1. Differences between antenna setup,

Date: 04.02.2020

Top view of the antenna plate ID ISC.ANT1710/690 Crystal Gate Wave

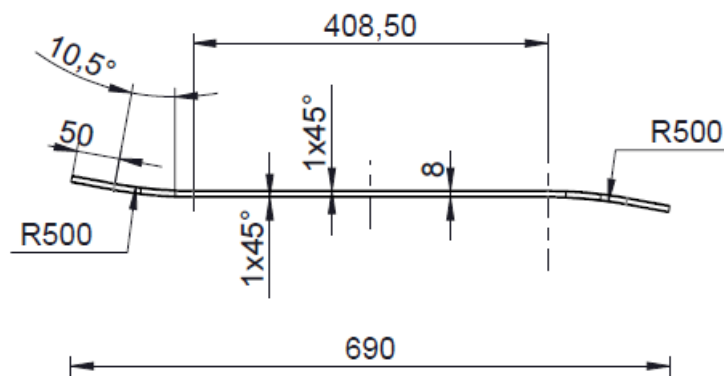
- **ID ISC.ANT1710/690-B Crystal Gate (current antenna)**
- **ID ISC.ANT1710/690-B Crystal Gate Wave (new antenna)**
 - We changed the total dimensions of the antenna plate from 1700mm x 682mm (ID ISC.ANT1710/690-B Crystal Gate) to 1488mm x 690 mm (ID ISC.ANT171/690-B Crystal Gate Wave).
 - We changed the shape of the acrylic antenna plate. The new antenna ID ISC.ANT171/690-B Crystal Gate Wave has an "S" shape. The current antenna ID ISC.ANT1710/690-B Crystal Gate uses a "Z" shape.
